VCBO® ADDENDUM 001

project	Intermountain PKH Sports Performance Center Phase 2	project no	20065.01
date	2023-10-25	no. pages	
owner	Intermountain Healthcare		
contractor			
bid date	2023-10-30	bid time	4:00 pm

Project: INTERMOUNTAIN PARK CITY HOSPITAL - SPORTS PERFORMANCE CLINIC

Revision: Addendum 001

MECHANICAL PIPING
DEMOLITION PLAN
FIRST FLOOR - AREA 1
(PHASE 2)
MPD111.1-2

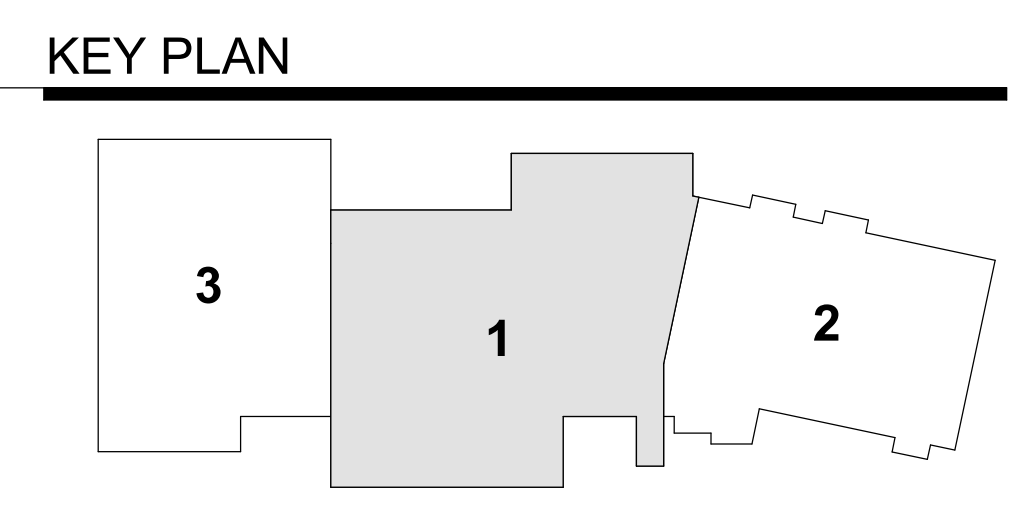
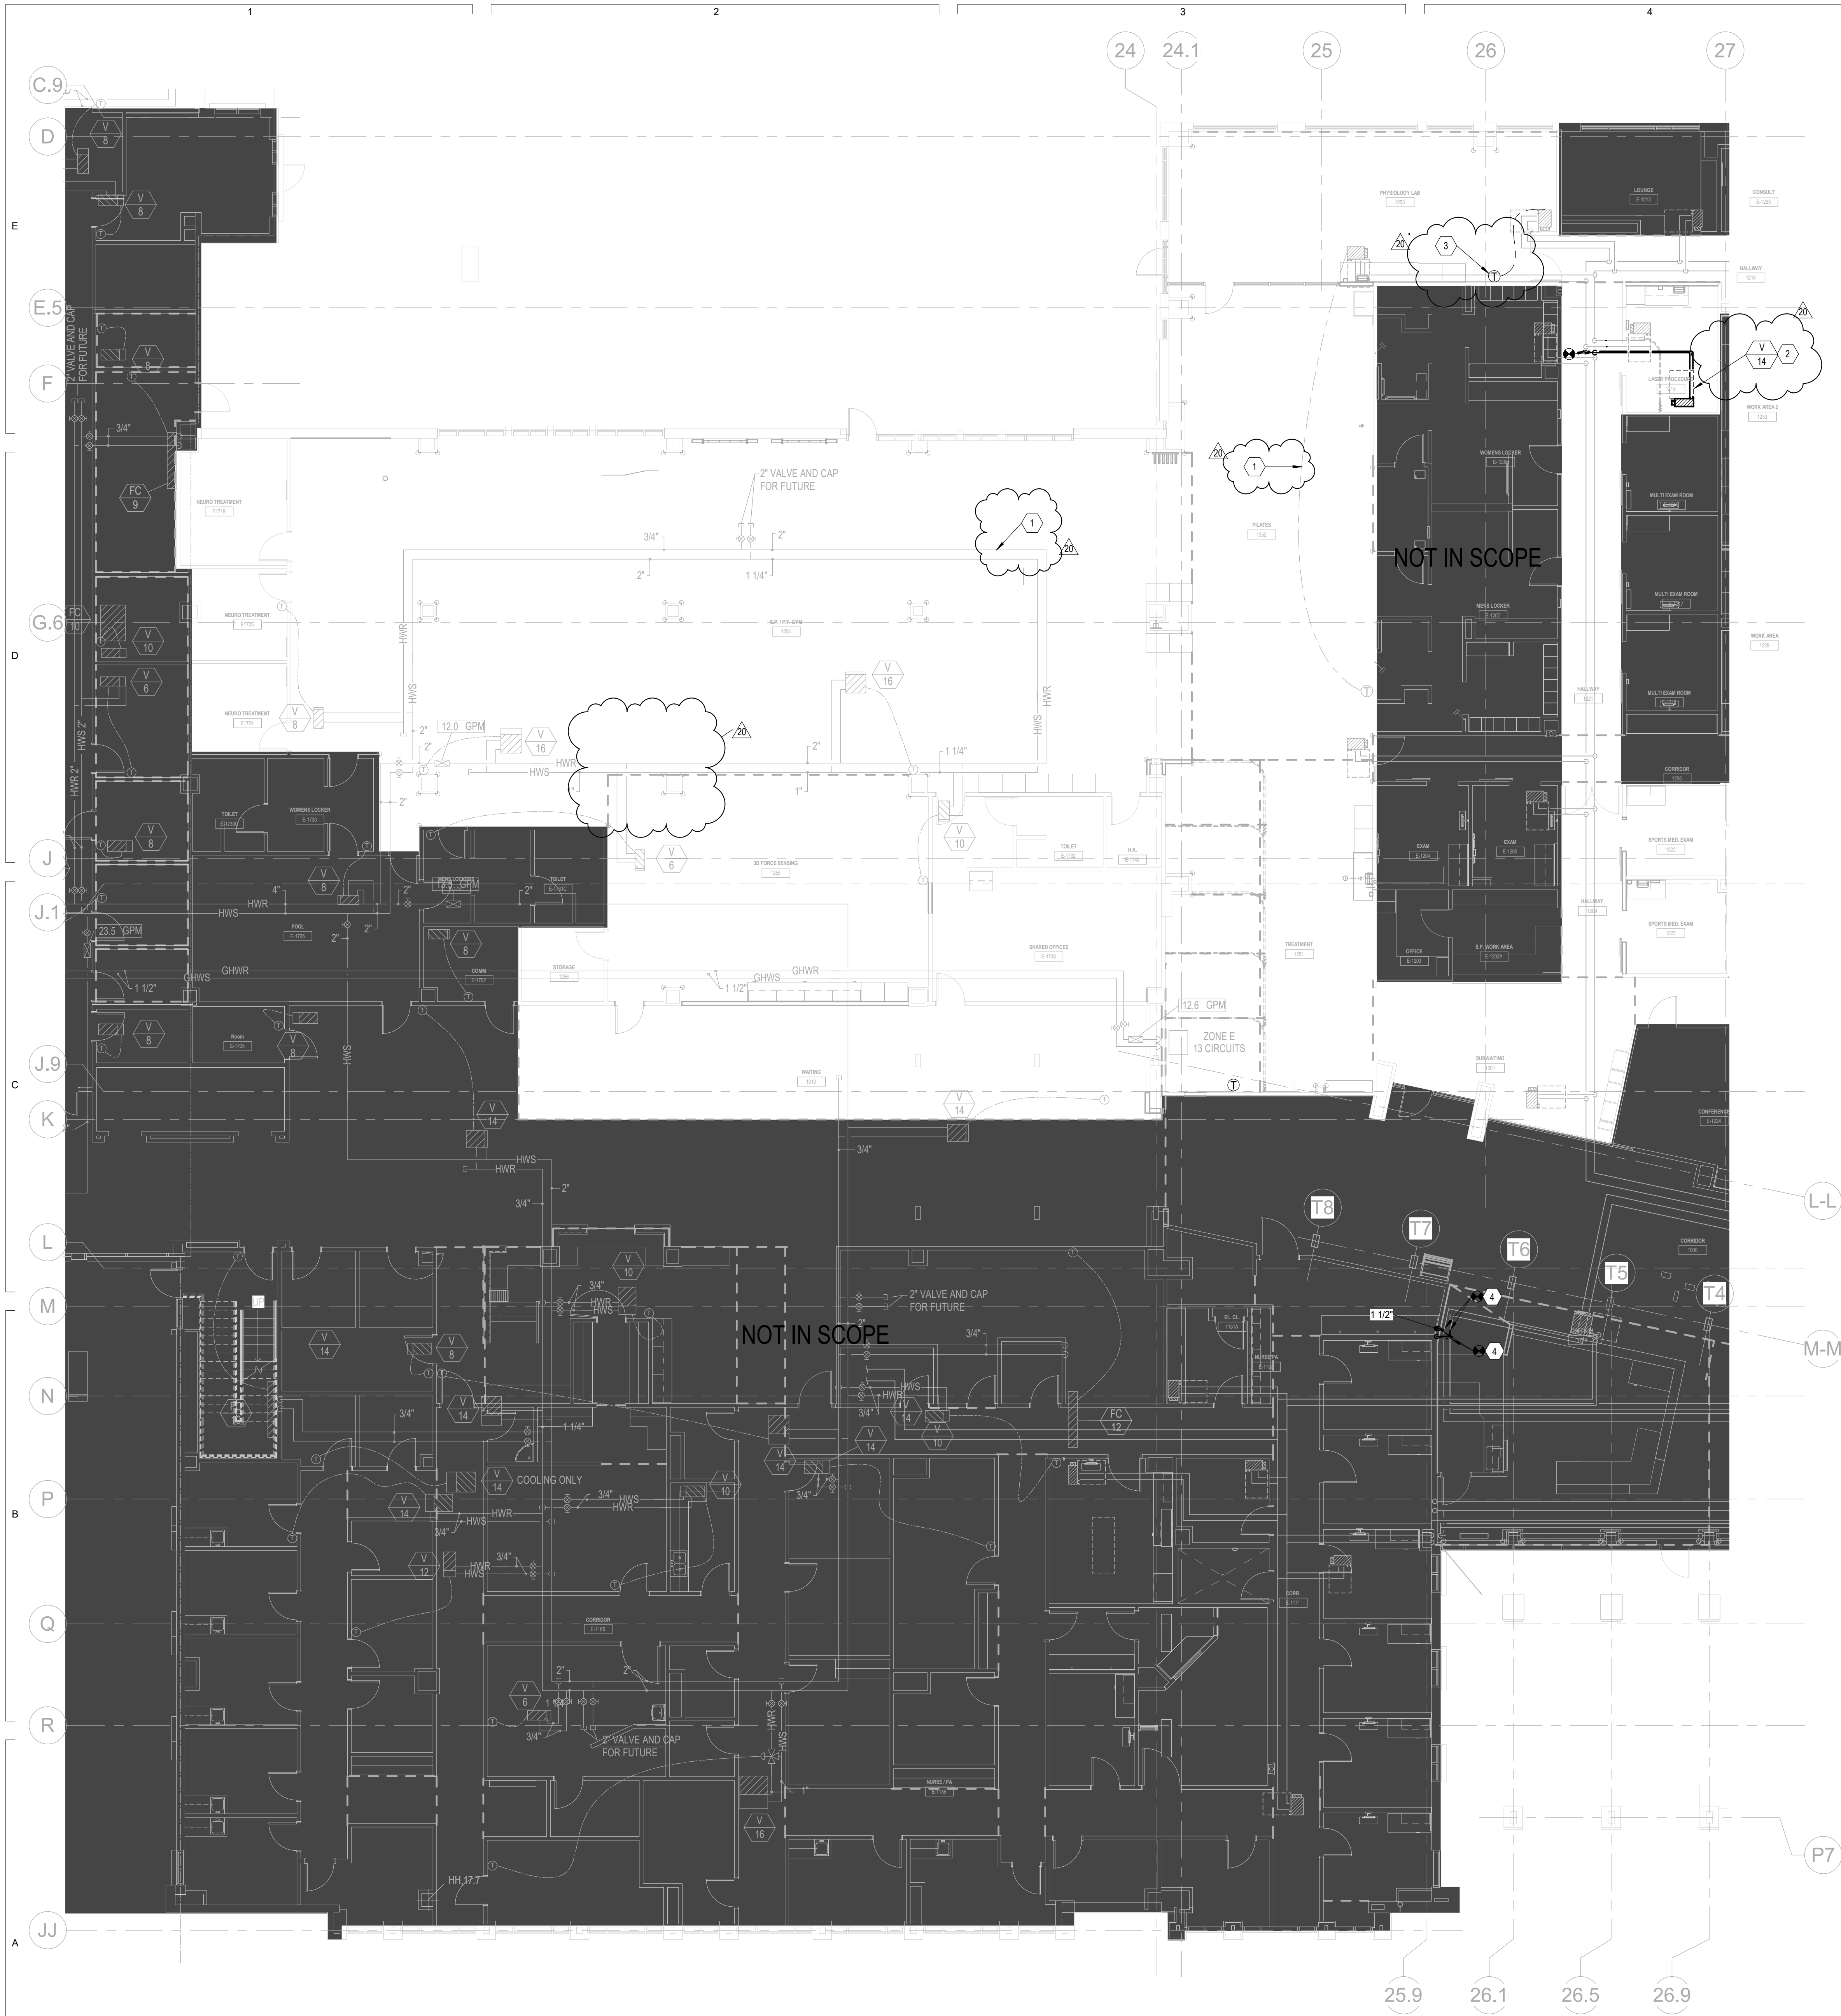
- Thermostat that was shown dark and indicated to be demolished remains.

MECHANICAL PIPING
 PLAN FIRST FLOOR -
 AREA 1 (PHASE 2)
MP111.1-2

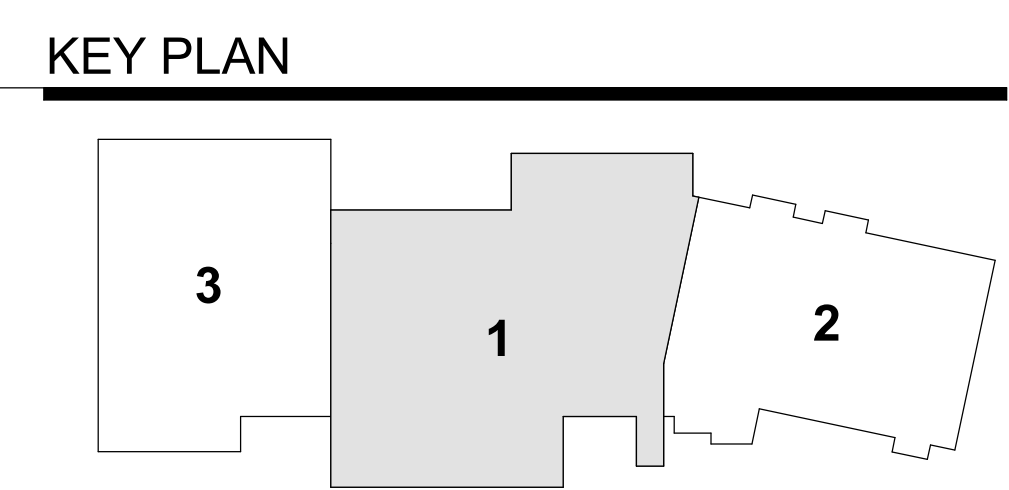
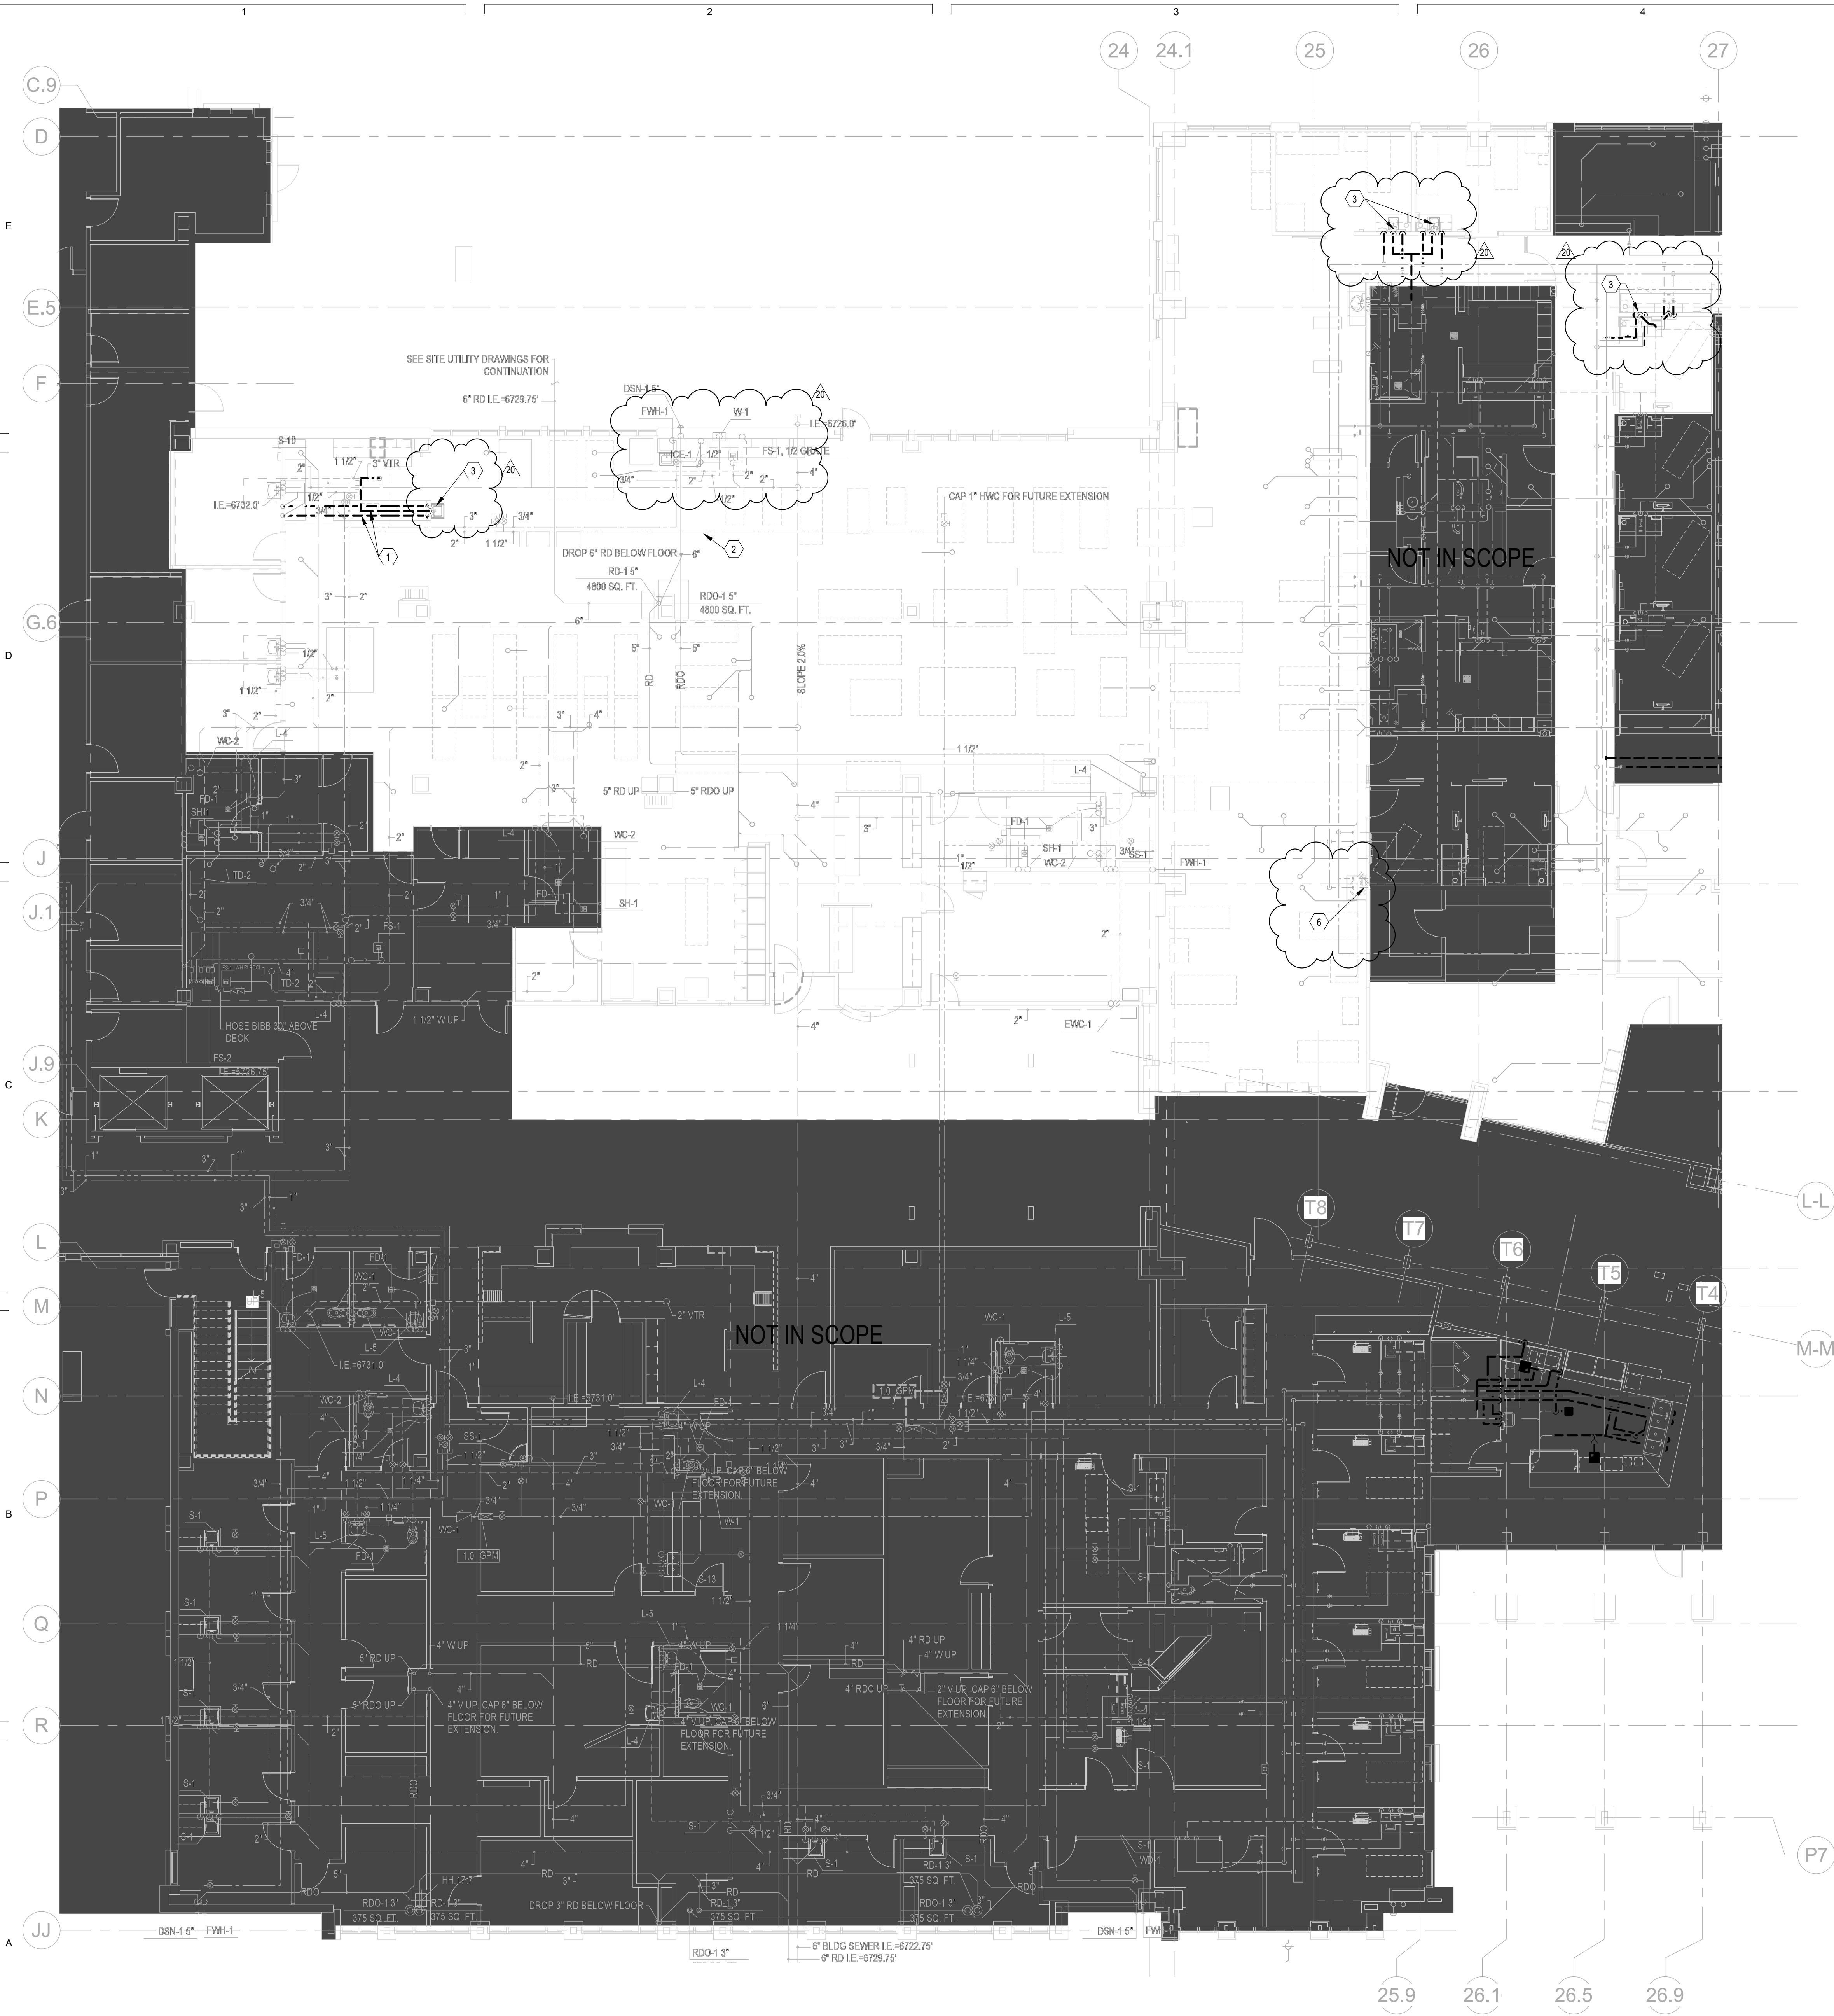
- Thermostat in Physiology Lab (1253) location updated to be next to wall.
- keyed note 1 relocated.
- Pipes removed from scope of work.
